PMT-AN-1150

PEGASOS Refinement Project

Position on the ENSI late stage review observations of the PRP entitled: “ENSI Final Report: Review Approach and Comments Concerning the PEGASOS Refinement Project (PRP) and the PRP Summary Report” (ENSI-AN-9060)

Document Type Confidential	Date 17.10.2015	Reference Number PMT-AN-1150
Prepared N. A. Abrahamson  K. J. Coppersmith 	Checked L. A. Dalguer  P. L. A. Renault 	Version Ver. 6 - Final

Figure 1 Comparison of PEGASOS and PRP median hazard and fractiles.

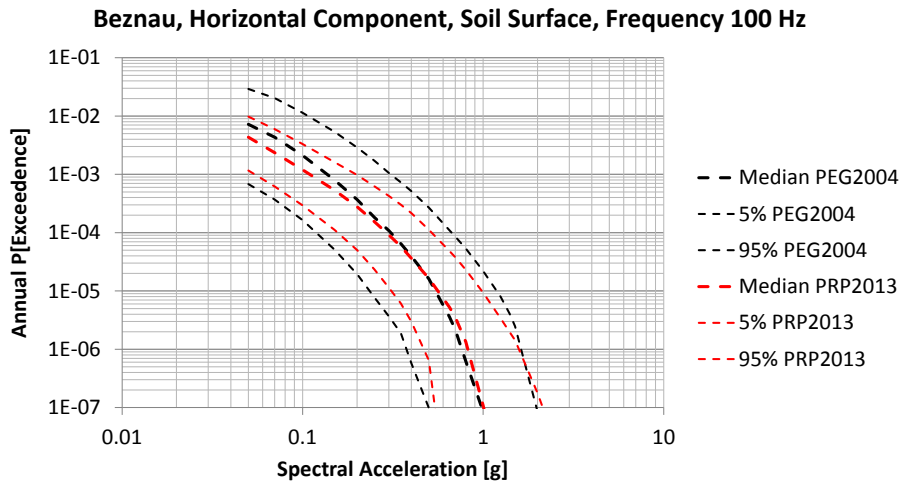
The robustness of the new PRP results compared to the old PEGASOS results can best be assessed when comparing the median and range of variability of the results. As can be seen from the illustrative example in Figure 1 the median hazard results are very consistent (also concluded by the ENSI-RT, see 5.1.3, page 40 in ENSI-AN-9060) and the range given by the fractiles demonstrate the achieved reduction of uncertainties.

Figure 3 Rock hazard comparison for the site Beznau at an annual probability of exceedance of 1E-4 for PRP and SED 2015.

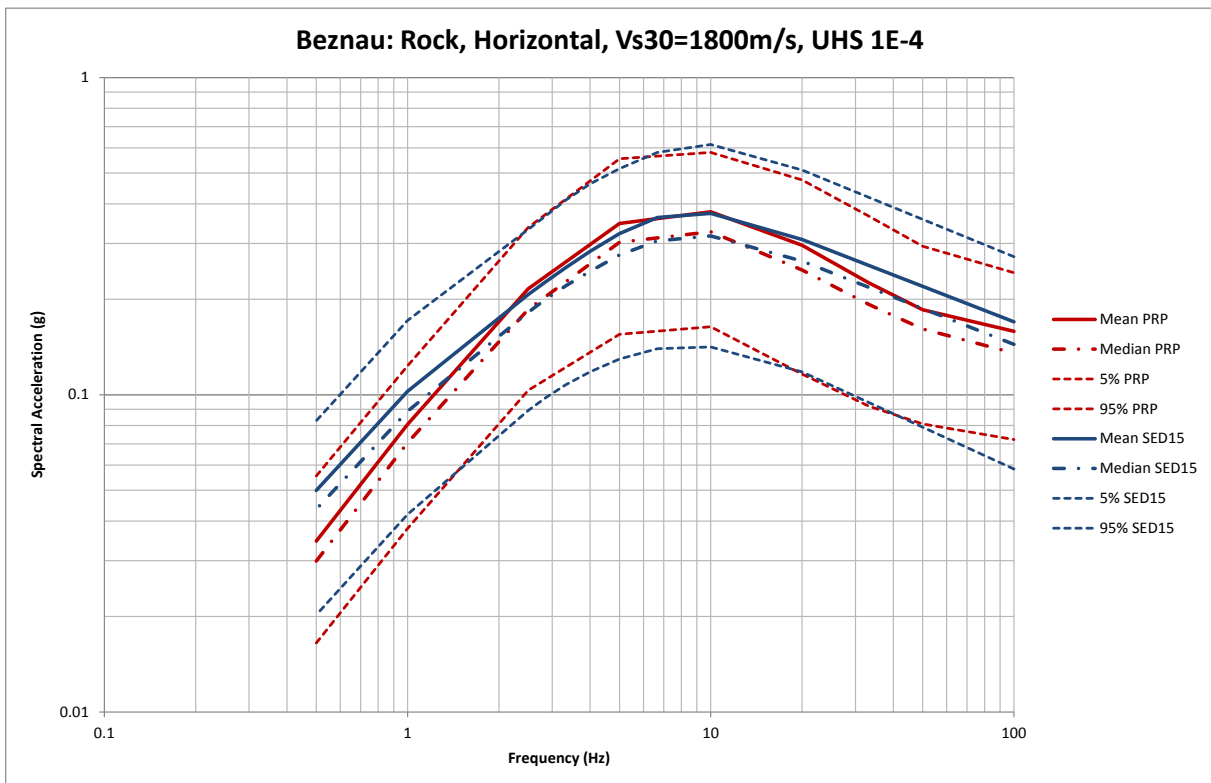
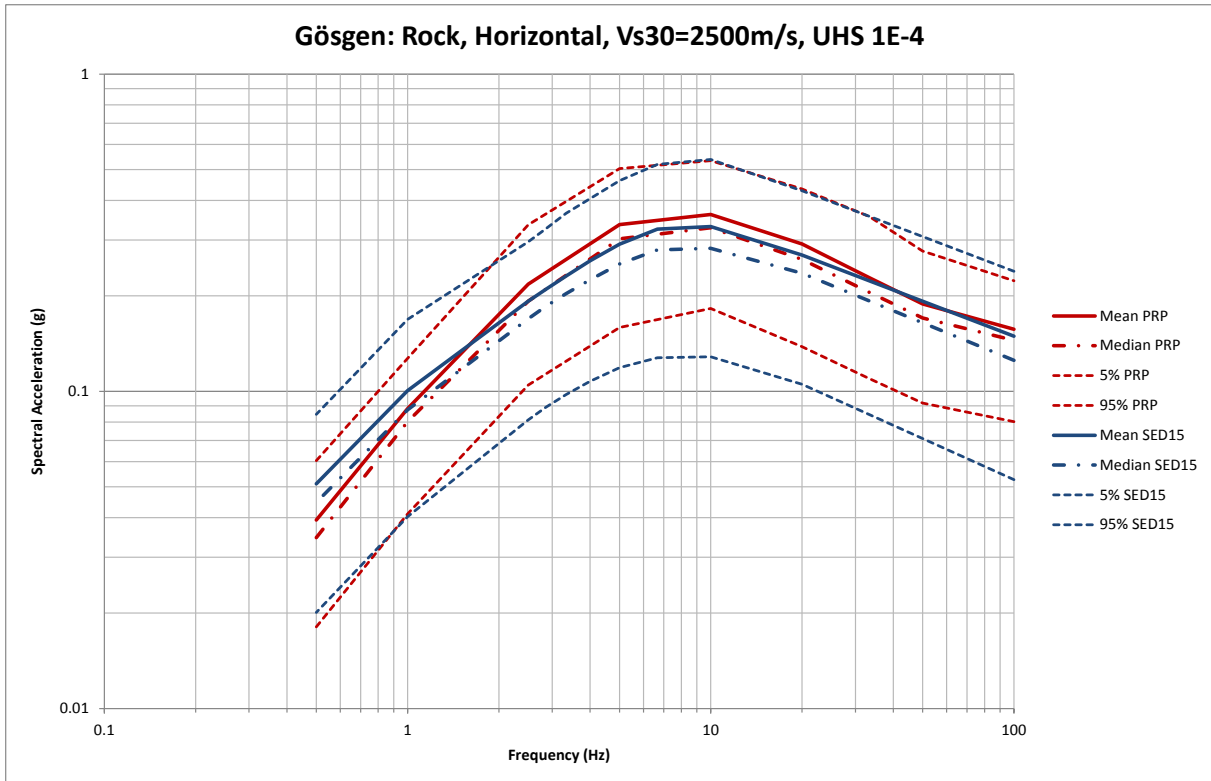
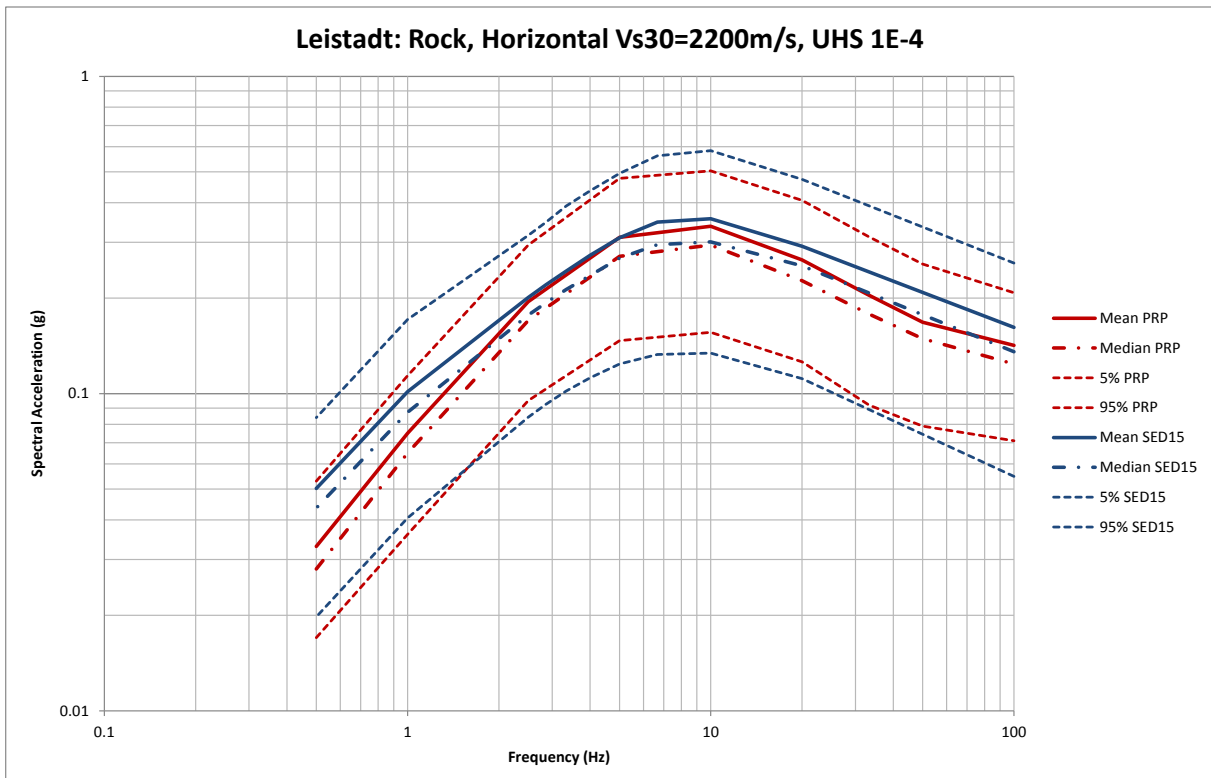
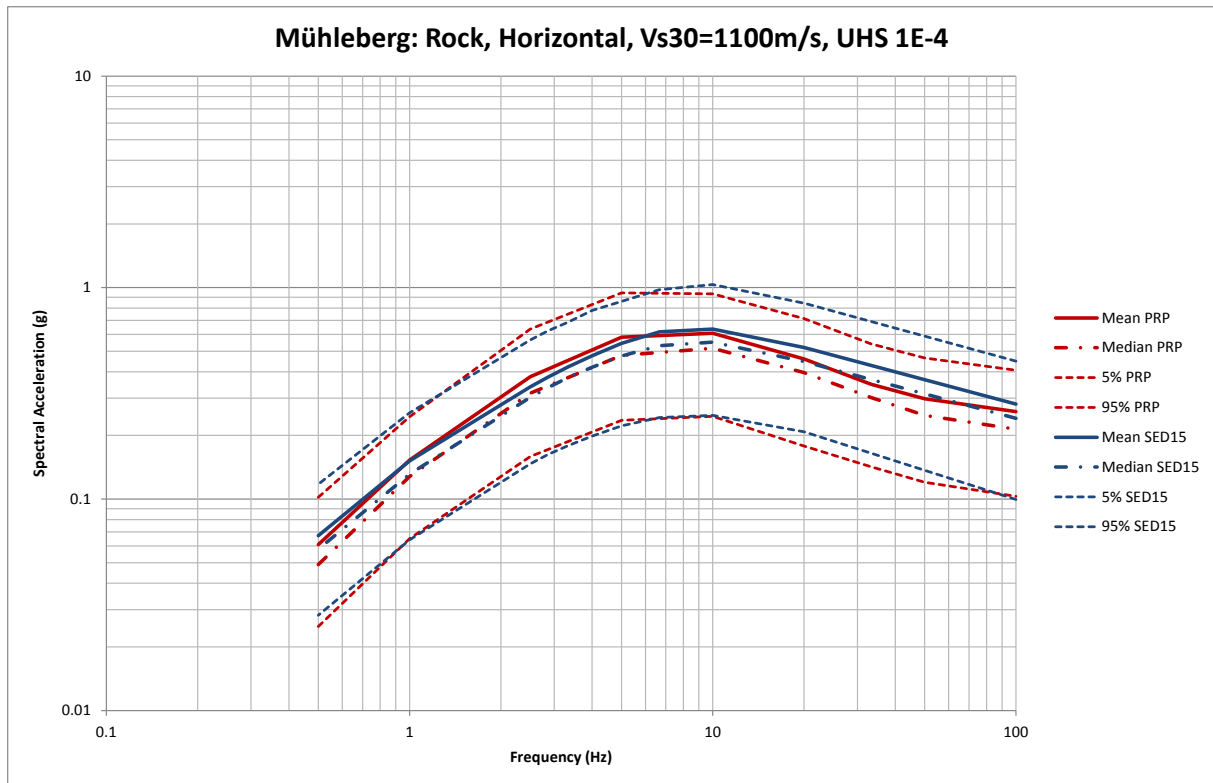
The four figures below show exemplarily the comparison at all the NPP sites of the rock hazard UHS for PRP 2013 and SED 2015 in terms of mean, median, 5% and 95% fractiles. The SED rock UHS consists of 11 spectral acceleration amplitudes for 11 frequencies. The comparison at rock (when converted to the same rock reference) provides remarkable consistency between SED and PRP results at all sites in terms of mean, median and fractiles. It is worthy to mention that there are fundamental differences when developing site specific hazard (PRP model) and regional hazard results at the scale of country (SED model). Nevertheless, what can be seen in this specific comparison is that despite the different model assumptions used to compute the hazard the resulting hazard (here shown in terms of UHS at 1E-4) is consistent and comparable.
